Summary of issues raised in the submission and responses from the Applicant and Council officers

Response to objection to proposed development of land described as 26 Second Avenue, Blacktown (Lot 80 DP11157)

Figure 1: Extract from the proposed Site Plan A1000 demonstrating the relationship of the proposed development site (outlined in red) and development currently under construction at 28 Second Avenue, Blacktown

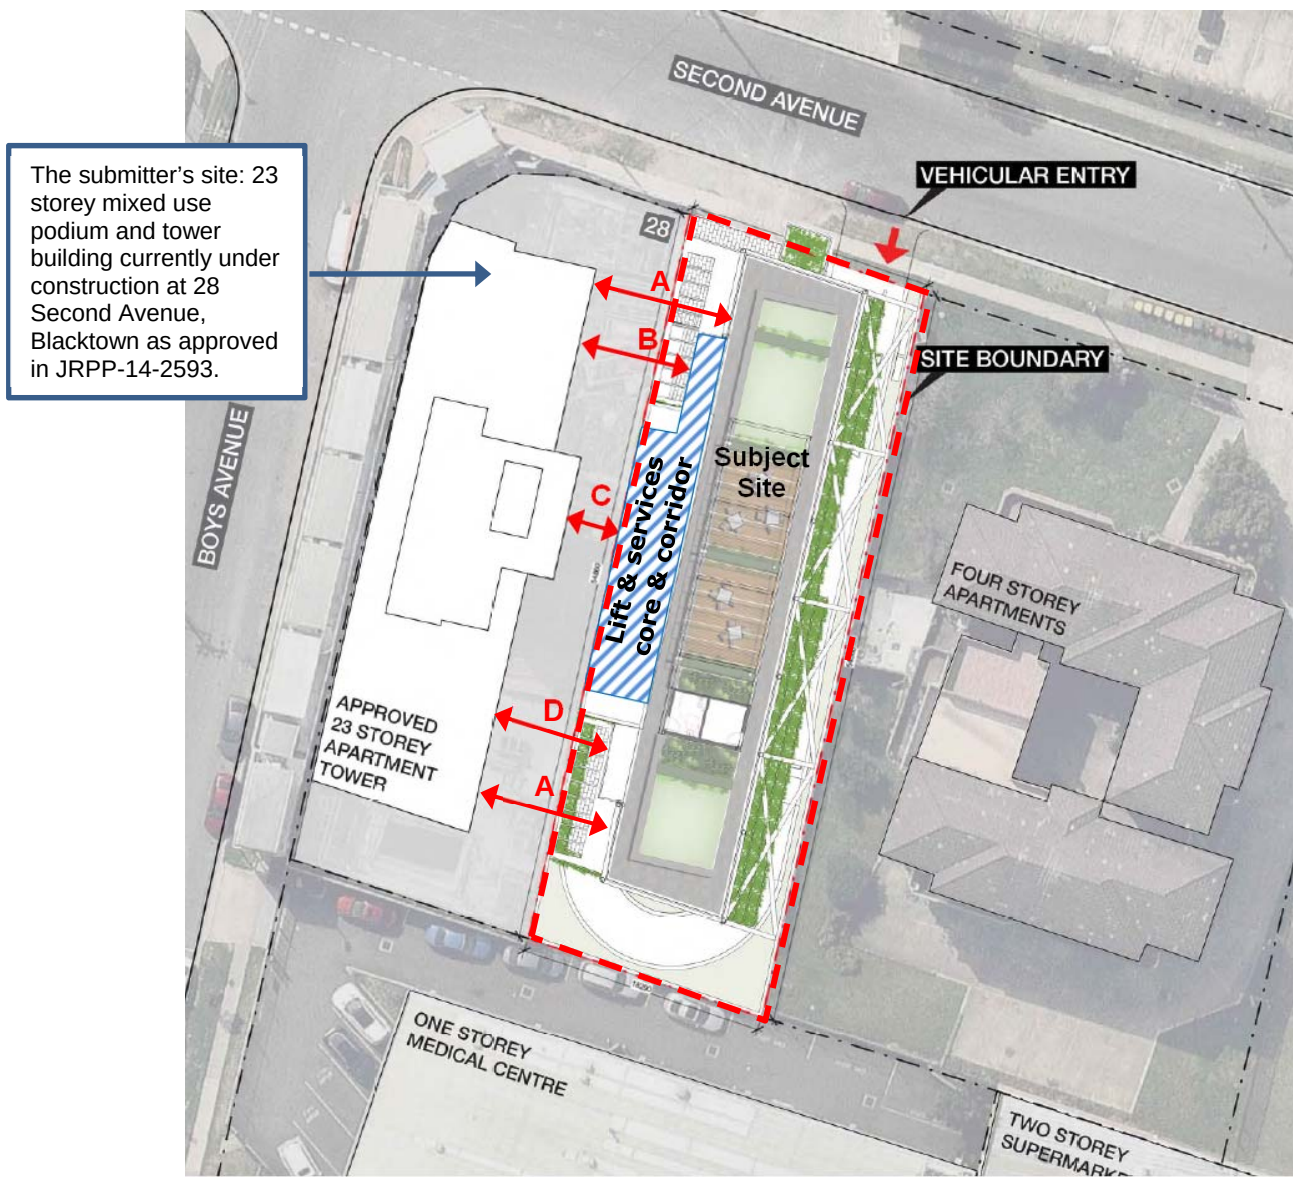
1. Setbacks:
 - a. The nil setback to the western boundary of the site for the services core of the proposed development is inadequate and results in adverse associated impacts including:

- overlooking
 - acoustic impacts
 - ventilation
 - solar access
 - amenity for the future residents at 28 Second Avenue
 - structural integrity.
 - b. The setback to the western boundary (being only 3 metres to the access corridor and 4.7 metres to the apartments) should be a minimum of 6 metres. The development at 28 Second Avenue achieves a 6 metres setback for the majority of the building.

The proposed setbacks of this development, and their relationship to the adjoining property to the west at 28 Second Avenue, are detailed in **Part B** above.

The proposed setbacks do not strictly comply with the ADG as detailed in Section 7 of the Assessment Report.

Figure 2: Extract from the proposed North Elevation Plan A3000 demonstrating the streetscape presentation of the proposed development (left) and the approved north elevation plan of the development currently under construction at 28 Second Avenue, Blacktown (overlaid on the right).

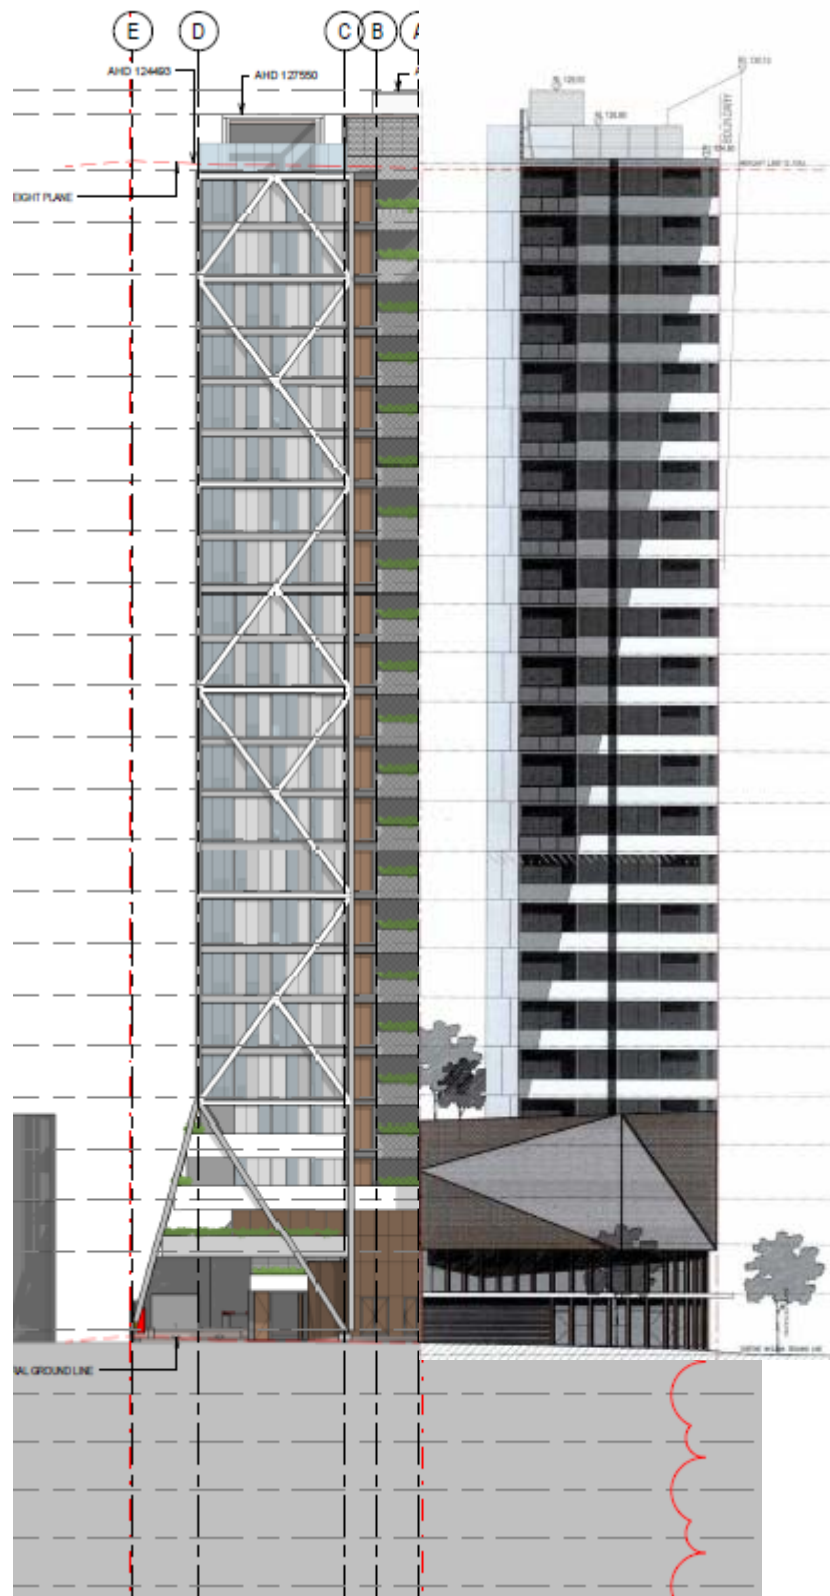
- b. The narrow allotment is unsuitable for the proposed development
 - c. Streetscape impacts as the proposed podium and tower are misaligned to the development at 28 Second Avenue

The approved development at 28 Second Avenue provides an interesting and unique architectural design, however we do not consider that it offers a design which is either a continuation of the scale of the podium previously approved at 26 Second Avenue, or likely to be continued by the redevelopment of any adjoining sites. Similarly, the proposal the subject of this application provides an overall tower form which is consistent with the development at 28 Second Avenue, however does not strictly copy the scale of the podium and tower form of 28 Second Avenue. As demonstrated in **Figure 2** on page 5, this application proposes a distinct podium and tower form which is generally the same overall width of the tower at 28 Second Avenue. This approach enables both sites to achieve a suitable building footprint for each level, which is sited to the western side of each site.

We consider the proposal to provide a suitable outcome with regard to the siting of the podium and tower form, its streetscape presentation and overall height and skyline. Furthermore, the proposal is supported by our City Architect as this proposal is considered to offer a positive outcome and contribution with regard to street activation and design excellence.

Figure 6: Analysis of the relationship between the window/balcony openings of the proposed development (above) and the adjoining mixed use development at 28 Second Avenue (below). The example shown is for Levels 10 and 11.

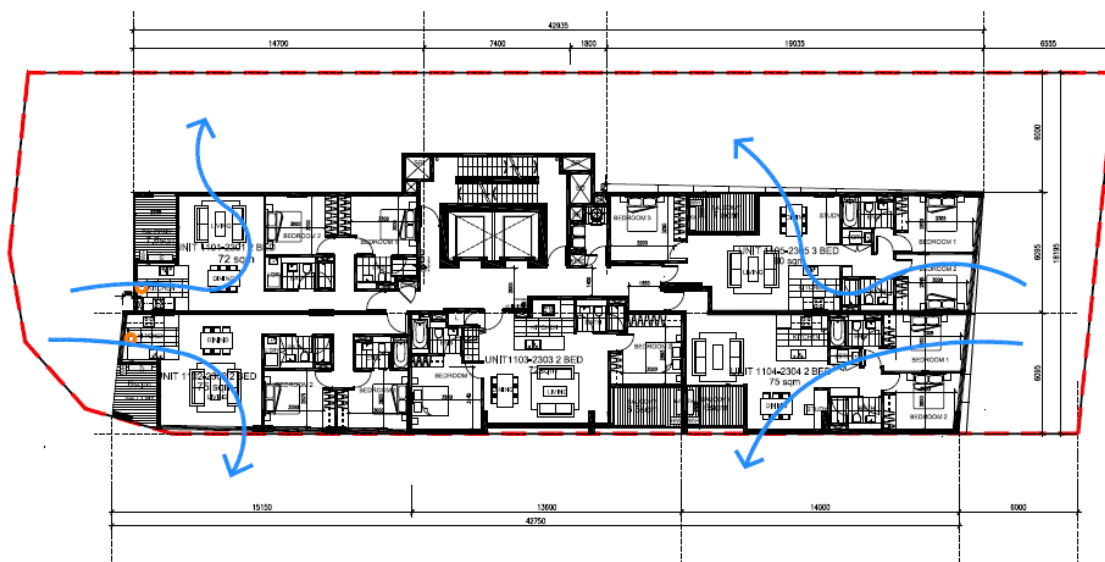
The submitter has raised concern with regard to visual privacy and overlooking impacts due to the close proximity of habitable rooms between the two developments. The proposed development comprises a blank wall for the majority of the western elevation, an unopenable window to the entry foyer / open plan living areas of the rear apartments on Levels 3 to 22 (3 metres from the shared boundary), and 2 unopenable windows to the access corridor (3 metres from the shared boundary).

These windows are proposed in this location at our request due to the large extent of blank wall along the western façade of this building, to break up the building mass. These windows are proposed to be 'bronzed' glazing, to create a tinted and visually interesting effect. Although direct lines of sight can be achieved from these windows to the objector's development, it is recommended that the glazing of these windows is also translucent to ensure that the visual privacy of neighbouring apartments is protected. A condition of consent is recommended to be imposed to this effect.

Figure 8: Extract from the Shadow Diagrams for JRPP-14-02593 for the mixed use development at 28 Second Avenue, Blacktown (Source: Tony Owen Architects, dated December 2014).

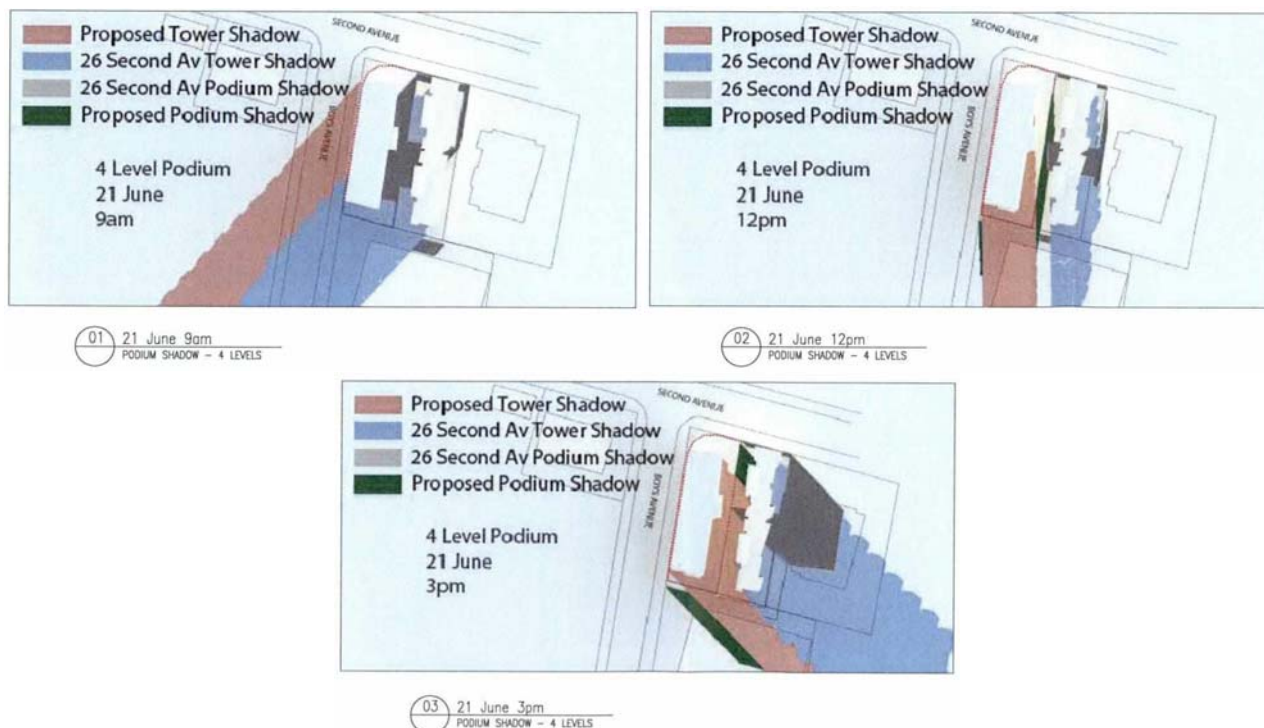
9. Side setbacks are to be 6 metres.
10. Building separation is to be at least 12 metres.
11. Lack of solar access to the future residents at 28 Second Avenue, with the apartment within the south-east of 28 Second Avenue receiving no solar access at midwinter.

As demonstrated in the above figure, it is anticipated that the redevelopment of 28 Second Avenue will overshadow the majority of the building at 28 Second Avenue at 9 am at midwinter. By midday, neither of the developments overshadow each other at midwinter. From approximately 1 pm onwards at midwinter, the development at 28 Second Avenue begins to overshadow the subject site.

The proposed Shadow Diagrams provided at **Attachment 5** indicate that the proposed development will overshadow the adjoining site at 28 Second Avenue in the morning throughout the year, however the shadow impacts are clear of 28 Second Avenue by midday. However, this overshadowing is minimal.

Figure 9: Analysis of the orientation of the 6 apartments (highlighted in yellow) on Levels 5 to 10 within the development at 28 Second Avenue, Blacktown which are single aspect to the west. The potential view lines, which are clear of the proposed development, are demonstrated by the blue lines.

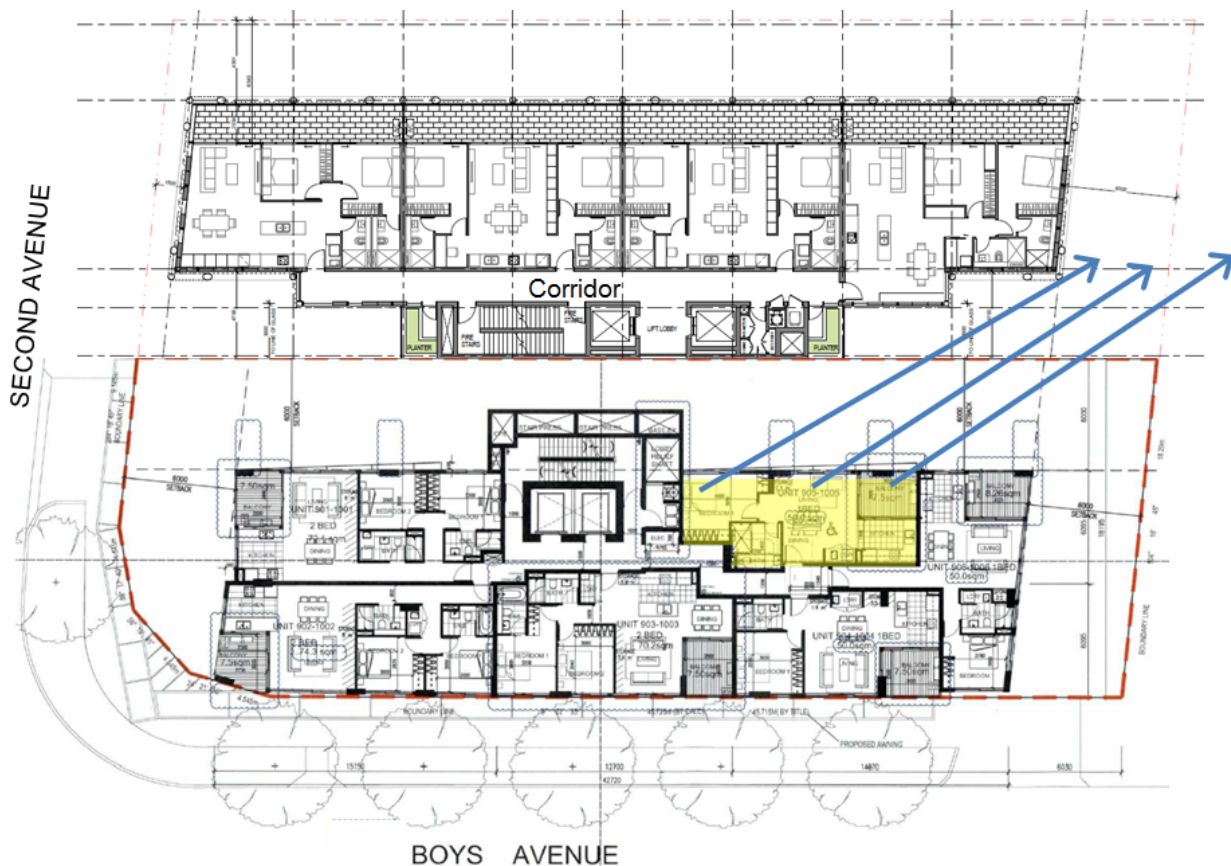
The submitter objects to the reduced setback and presentation of the western elevation and blank wall effect of the proposed development, and the resulting loss of amenity for the future occupants at 28 Second Avenue.

Of the 106 apartments at 28 Second Avenue, 6 are solely east facing (located on levels 5 to 10). A further 40 apartments are also east facing, however their primary orientation is either to the north, or to the south and west. The following figure identifies the location of these 6 apartments which are solely east facing and their relationship with the proposed development.
